**RE-NOTIFICATION OF UNREMEDIED SAFETY
DEFECT ON YOUR BLUE BIRD BUSES**

SUBJECT: RECALL R13WD GRID HEATER POWER CABLE MAY CONTACT
FRAME RAIL

R13WD

Grid Heater Power Cable May Contact Frame Rail

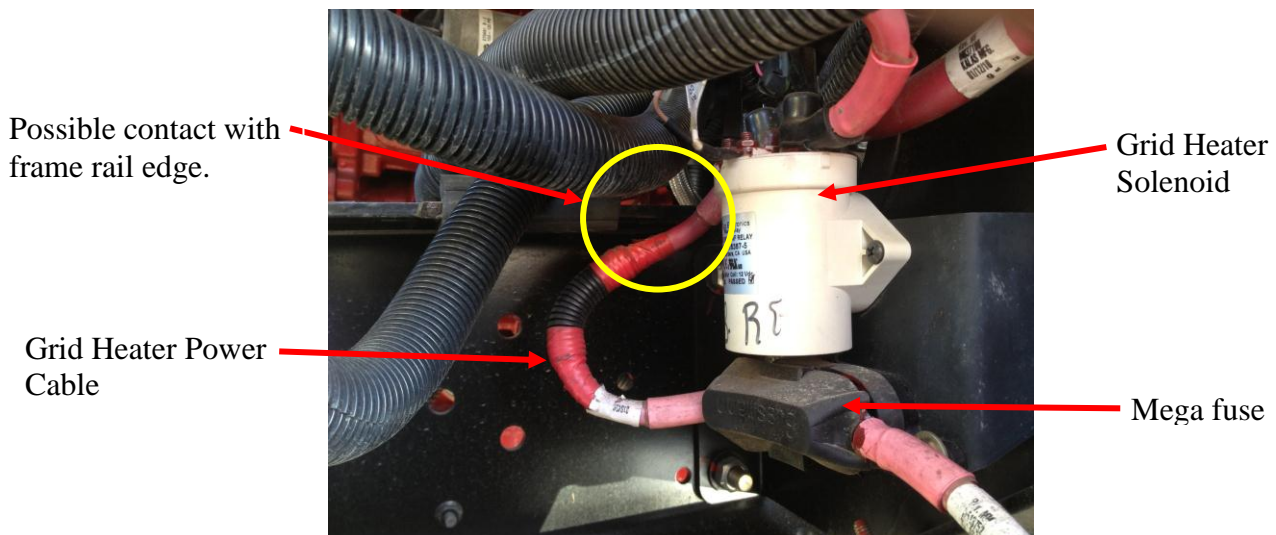
The grid heater power cable may be improperly routed which could result in contact with the chassis frame rail. If the cable contacts the chassis frame rail it could potentially chafe against the frame thereby creating a short which could result in a fire.

Inspect for proper positioning of the grid heater power cable. If any grid heater power cable is contacting the frame rail, remove and inspect. If there is any damage, replace cable and install per instructions below. If there is no damage, reinstall per instructions below.

ILLUSTRATION 1

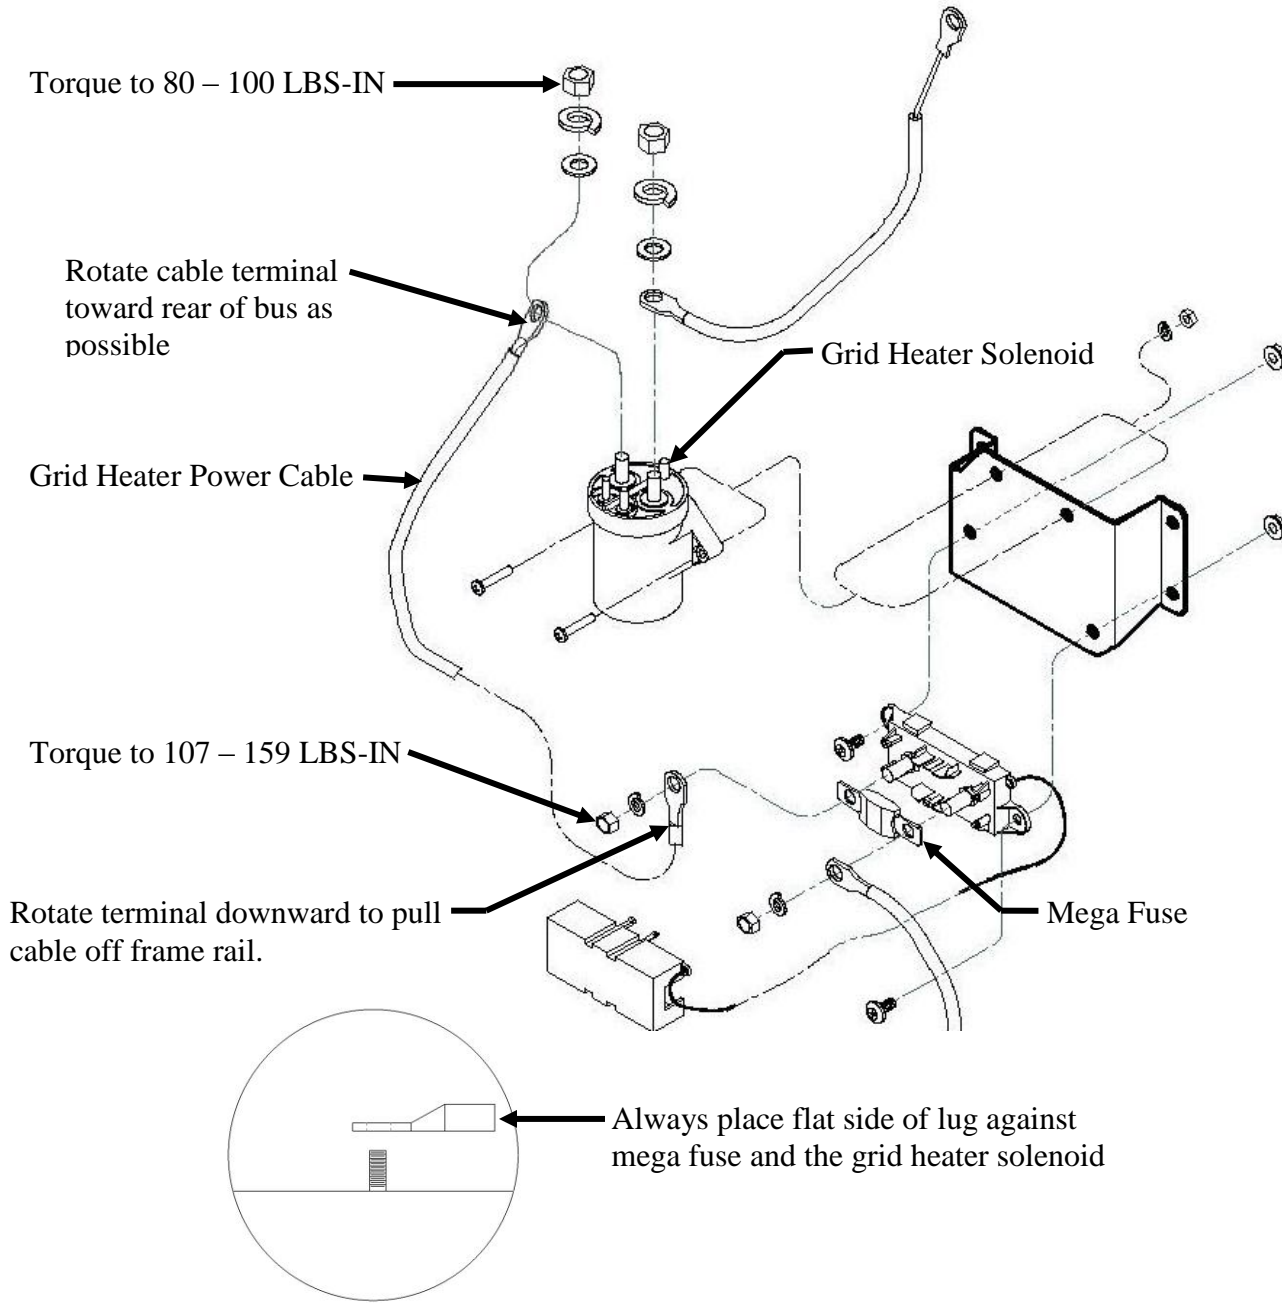
4. **If the grid heater power cable is contacting the frame rail edge:**
 - a. Disconnect the battery cables by removing the negative cable first and then the positive.
 - b. Remove the grid heater power cable and inspect for any damage to the cable. If no damage, reinstall per Illustration 1 on page 3. If there is any damage, contact Blue Bird Recall Administrator for replacement cable, replace cable and install per Illustration 1 on page 3.
 - c. Reconnect the battery cables, positive first and then negative.
 - d. Place bus back in service.

5. **If the grid heater power cable is not contacting the frame rail edge but is close to the frame rail edge,** the cable must be repositioned to provide maximum clearance to frame rail. Do not bend the cable away from the frame rail, it **MUST** be repositioned:
 - a. Disconnect the battery cables by removing the negative cable first and then the positive.
 - b. Remove the grid heater power cable and reinstall per Illustration 1 on page 3. If there is any damage, replace cable and install per Illustration 1 on page 3.
 - c. Reconnect the battery cables, positive first and then negative.
 - d. Place bus back in service.

6. **If the grid heater power cable is already positioned per Illustration 1 on page 3, no further action required.**

GRID HEATER CABLE INSTALLATION
